Product Change Notification (PCN)

PCN Number	510049	Date Issued	May 14, 2021
Reason for Change	Change to Product		
Change Type Description	This letter is to inform you that changes are being made to the part(s) identified in this Notice. The change may affect the fit, form, function or appearance of the parts, or it may result in a change to the specification. The pictures below show an example of the possible differences.		
Reason for Short Notice	Corrective Actions		
Assessment of Change	Test report/Specification Test Report		
Internal Molex Qualification Date	May 28, 2021		
Sample Availability Date (Changed Part)	May 28, 2021		
Planned Implementation Date	July 01, 2021		
Method of Identifying Change	Lot information on label

Overview

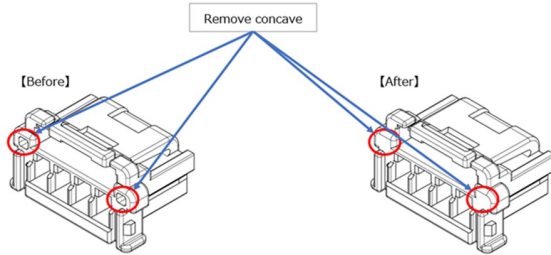
- Change Point:
 - Remove the concave and then return to the original size of the air venting
- Reason:
 - To reduce quality risks of Bubble & Gate flash
- Product Impact
 - Impact to cosmetic appearance. But there is no change of Fit or Function.
- Part Number Impact
 - 505151-0301/505151-0401/505151-0501/505151-0601/505151-0701/505151-0801/505151-0901
 - 505151-1001/505151-1101/505151-1201/505151-1301/505151-1401/505151-1501/505151-0300
 - 505151-0400/505151-0500/505151-0600/505151-0700/505151-0800/505151-0900/505151-1000
 - 505151-1100/505151-1200/505151-1300/505151-1400/505151-1500
- Qualification Reports and samples available upon request after 1st of May,2021
